LYNDHURST GARDENS

GENERAL ARRANGEMENT

PROJECT NO. 639/14	DRAWING NUMBER: GA001	REVISION: P03
-----------------------	--------------------------	------------------

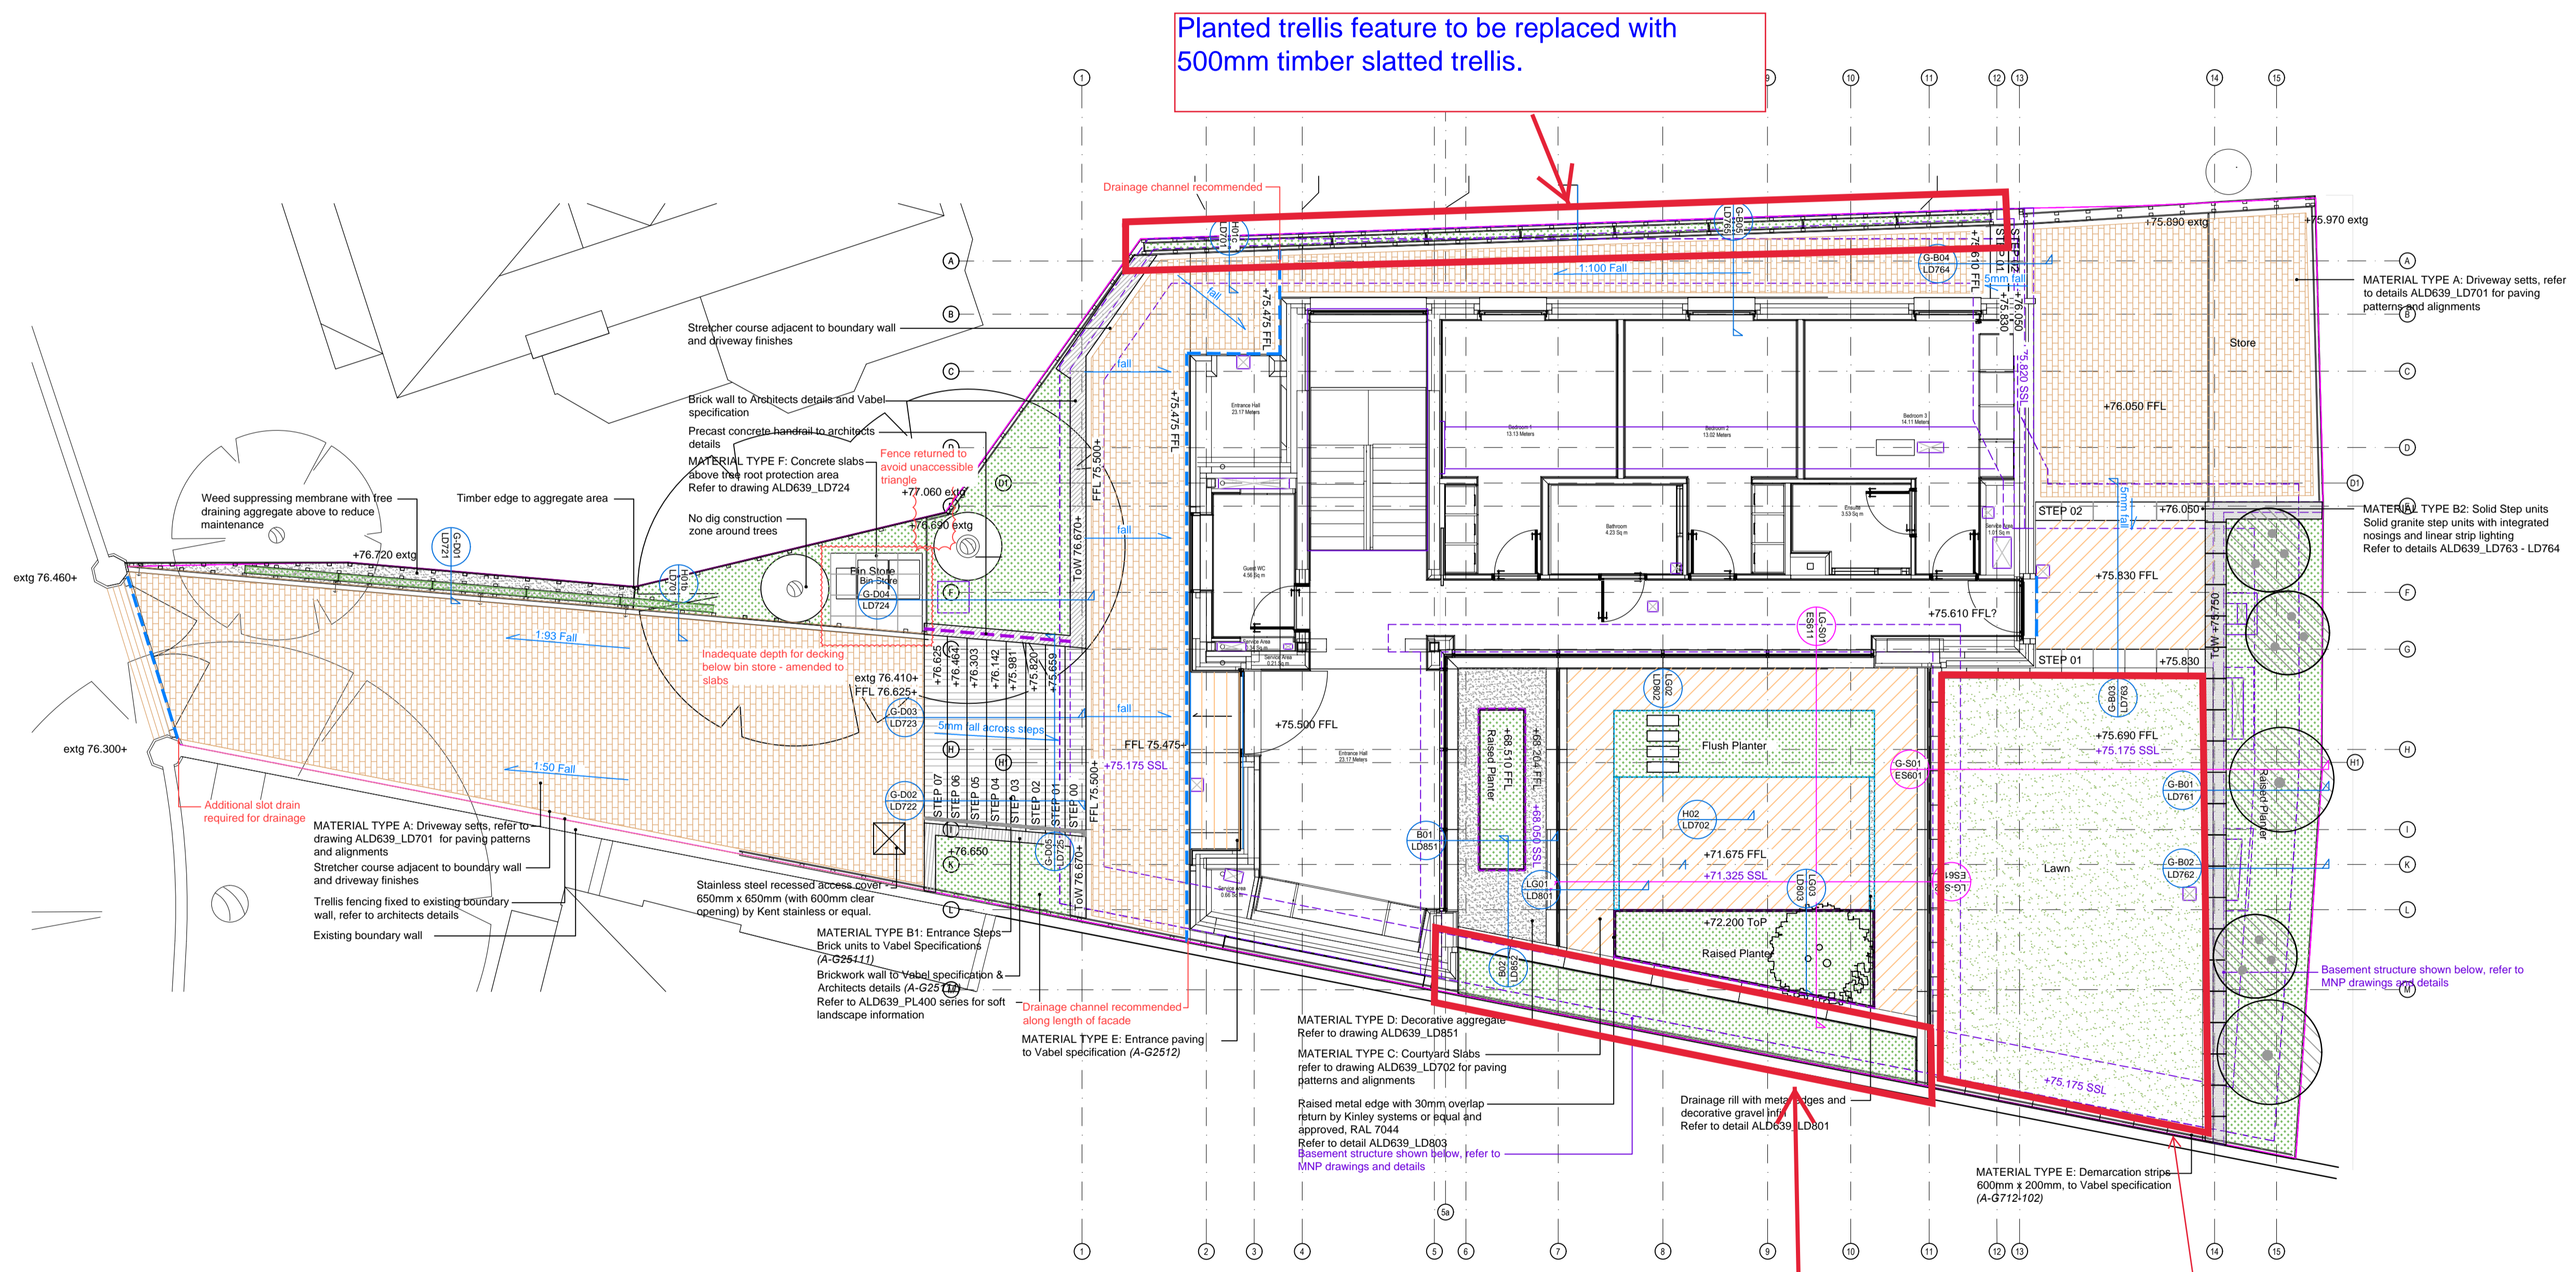
Planted trellis feature to be replaced with 500mm timber slatted trellis.

Area of planting to be omitted and changed to paving to allow for access for maintenance to the site boundary. Glass balustrade to be introduced to provide guarding along the light well edge to make the area safe for working. See Drawing Number 3104 for details.

Grass lawn replaced with artificial turf due to maintenance concerns.
